TECHNICAL and SERVICE BULLETIN

No. 09

DESIGN CHANGE - Seal Backing Plate Assembly Part Number 922502

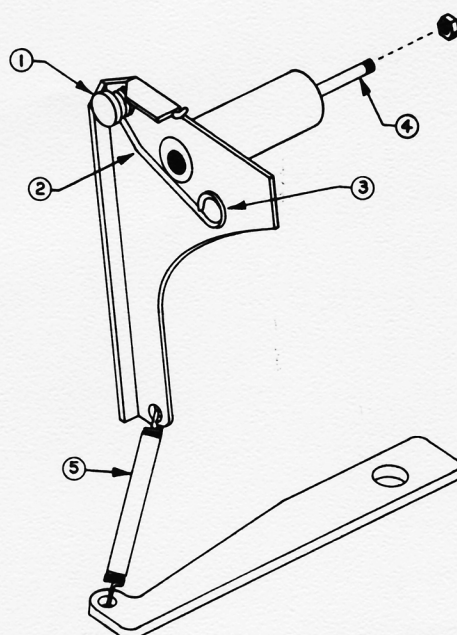
This design change incorporates 5 modifications which improve product reliability and performance.

1. The seal spring is securely fastened using a rivet instead of solder which was prone to failure.
2. The seal spring is a heavier gage steel which results in a more uniform seal wear and should add longer seal life.
3. A loop was added to the end of the seal spring which allows for convenient lifting when the seal sets are replaced.
4. A retaining pin is added to prevent the seal backing plate from contacting the Kompac II form roller. This will eliminate accidental damage to the form roller if the seals are used beyond the specified limits.
5. Spring cover reduces plate scratching and prevents ink and paper lint from clogging the spring coils.

Note - This nut must be installed after the unit is assembled.
